CONFIGURATION CHANGE		SHEET	EDM USE ONLY						
		1	CC No.						
		2	5						
			DATE 12-9-80						
REQUESTED BY WESLEY TAM	<input type="checkbox"/> SPECIFICATION <input checked="" type="checkbox"/> DRAWING <input type="checkbox"/> PROCEDURE <input type="checkbox"/> INSTRUCTION	REVISION 3	CLASS SR						
TITLE ELEM. DIAGRAM CYMTR FEED CV-517, CV-525, & CV-527	NUMBER 64350	SUPPLIER <input type="checkbox"/> BECHTEL <input checked="" type="checkbox"/> EDISON							
DESCRIPTION OF CHANGE		J.O. NO. 7764	W.O. NO.						
<p>1. CHANGE RELAY CONTACTS AND TERMINAL NUMBERS:</p>

J.O. NO. 7655	SAN ONOFRE NUCLEAR GENERATING STATION
FILE	ELEMENTARY DIAGRAM CONTROL VALVES (CV) CV 525 & CV 527
SOUTHERN CALIFORNIA EDISON COMPANY SCALE NONE LOS ANGELES, CALIF.

I.O. NO. 7255	SAN ONOFRE NUCLEAR GENERATING STATION
FILE	ELEMENTARY DIAGRAM CV MTR FEED CV-517, CV-525, & CV-527
	SOUTHERN CALIFORNIA EDISON COMPANY LOS ANGELES, CALIF.

AFTER
 Drwg. # 64350-3
 CC # 5
 Sheet # 2 of 2

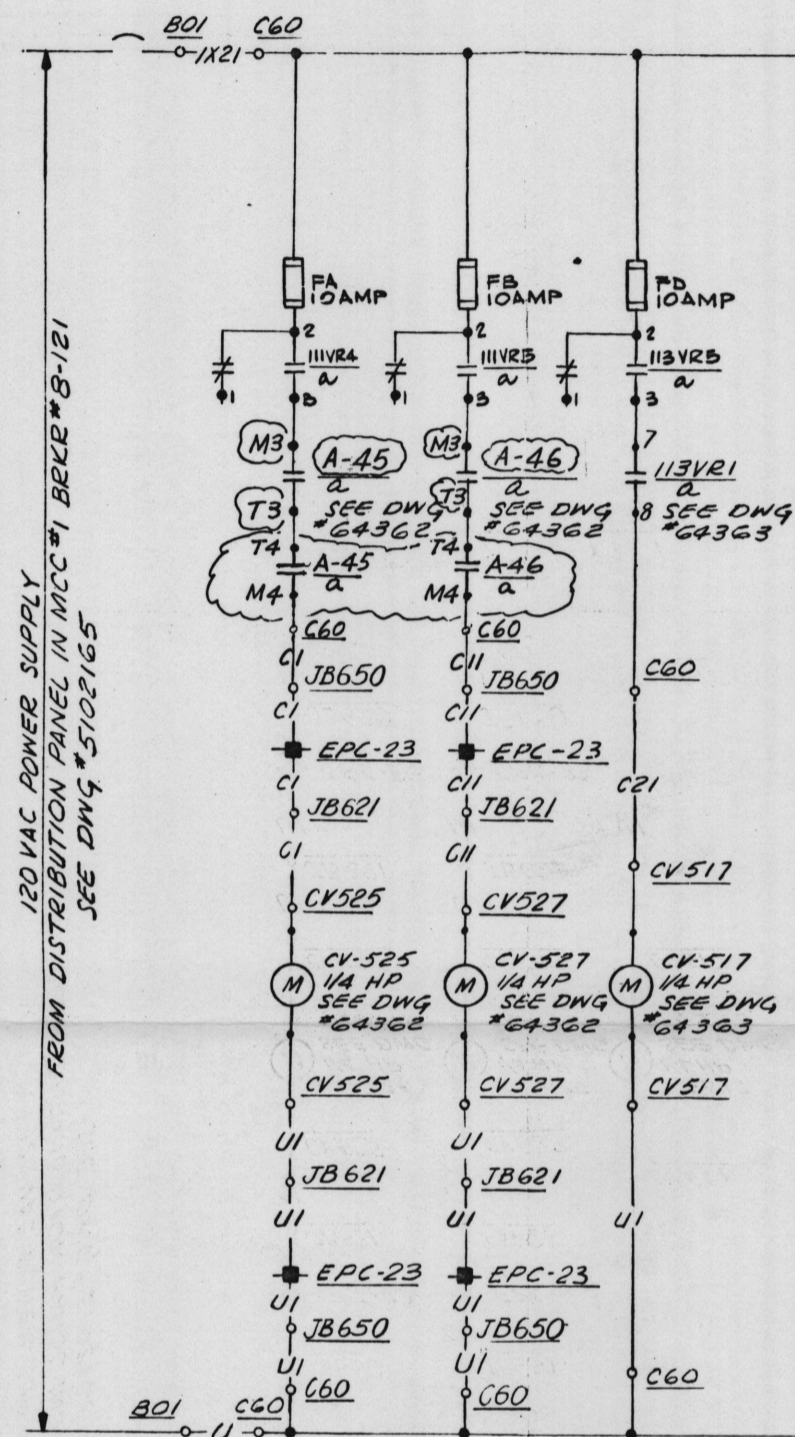
<table><tr> <td>FROM</td> <td>TO</td> </tr><tr> <td>$\frac{111VR1}{a}$ (5-6)</td> <td>$\frac{A-45}{a}$ (M3-T3) & $\frac{A-45}{a}$ (M4-T4)</td> </tr><tr> <td>$\frac{111VR2}{a}$ (5-6)</td> <td>$\frac{A-46}{a}$ (M3-T3) & $\frac{A-46}{a}$ (M4-T4)</td> </tr></table>

<p>2. ADD WORK PACKAGE NUMBER AND REMOVE THE TERM "NUCLEAR" FROM SAFETY RELATED CLASSIFICATION.</p>				FROM	TO	$\frac{111VR1}{a}$ (5-6)	$\frac{A-45}{a}$ (M3-T3) & $\frac{A-45}{a}$ (M4-T4)	$\frac{111VR2}{a}$ (5-6)	$\frac{A-46}{a}$ (M3-T3) & $\frac{A-46}{a}$ (M4-T4)
FROM	TO								
$\frac{111VR1}{a}$ (5-6)	$\frac{A-45}{a}$ (M3-T3) & $\frac{A-45}{a}$ (M4-T4)								
$\frac{111VR2}{a}$ (5-6)	$\frac{A-46}{a}$ (M3-T3) & $\frac{A-46}{a}$ (M4-T4)								
JUSTIFICATION REPLACE HFA RELAY WITH QUALIFIED IE AGASTAT RELAY FOR CONTAINMENT ISOLATION VALVES CV-525 AND CV-527. TMI-II W.P. # 2.1.4									
EVALUATION									
OTHER AFFECTED DOCUMENTS / DRAWINGS: DOCUMENT CHANGE REQUIRED FOR: <input checked="" type="checkbox"/> CONSTRUCTION <input type="checkbox"/> AS BUILT <input type="checkbox"/> OTHER _____									
FIELD APPROVALS		DESIGN APPROVALS							
ENGR./DISCIPLINE	DATE	CONSTR. SUPER.	DATE						
ENGR./DISCIPLINE	DATE	G.A. REP.	DATE						
ENGR./DISCIPLINE	DATE	STATION SUPT. POWER SUPPLY (RECORD REV.)	DATE						
RESPONSIBLE ENGR. <i>[Signature]</i> 12-8-80		INDEPENDENT REVIEW ENGR. <i>[Signature]</i> 12-8-80							
<input type="checkbox"/> ARCHITECTURAL DATE		<input type="checkbox"/> MECHANICAL DATE							
<input checked="" type="checkbox"/> CIVIL STRUCTURAL DATE		<input type="checkbox"/> ELECTRICAL DATE							
<input checked="" type="checkbox"/> CONTROLS DATE		<input type="checkbox"/> QUALITY ASSURANCE DATE							
<input type="checkbox"/> ELECTRICAL DATE		<input type="checkbox"/> PROJECT ENGINEER DATE							
<input type="checkbox"/> CONSTRUCTION DATE		<input type="checkbox"/> CHECKER (AS APPROPRIATE) DATE							
DISC SUPERVISING ENGR. <i>[Signature]</i> 12-25-81		STA. SUPT. - P.R.
